Final Drainage Report

Citizen on Constitution El Paso County, Colorado

Prepared: January 27, 2022
Revised: March 28, 2022
Revised: May 23th, 2022

PCD File Number: SF-22-006

DETENTION BASIN OUTLET STRUCTURE DESIGN

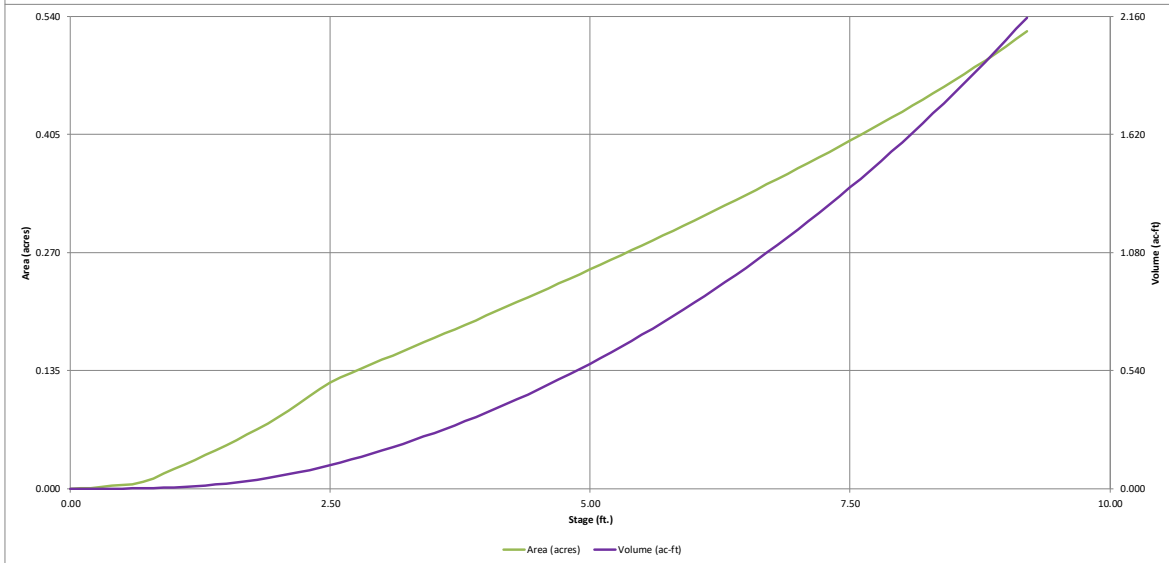
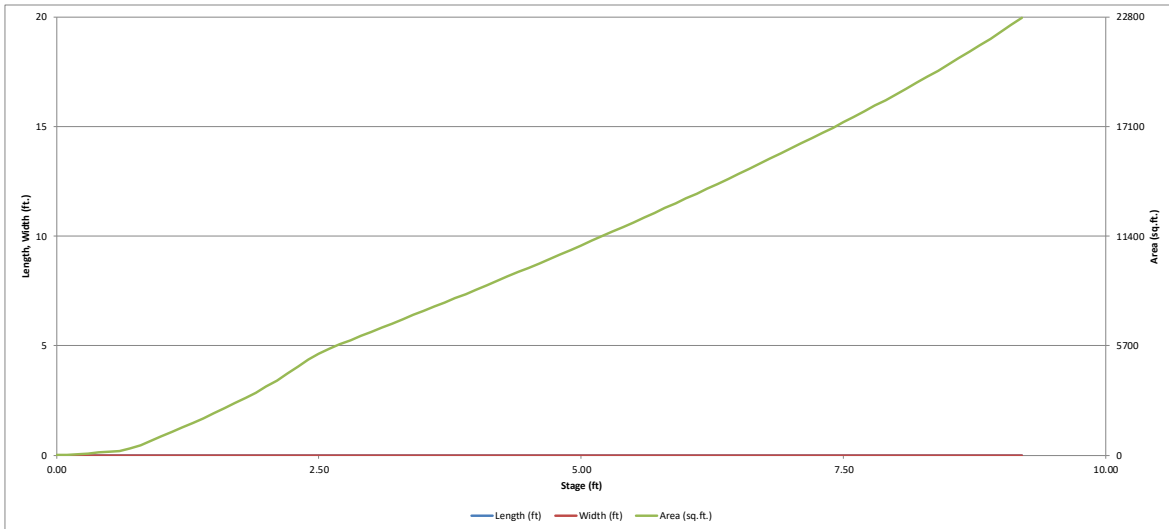
the orifice area doesnt match the pond details. Revise so that they are consistent

Sht C4.13 shows front edge and side length to each by 4ft. Revise.
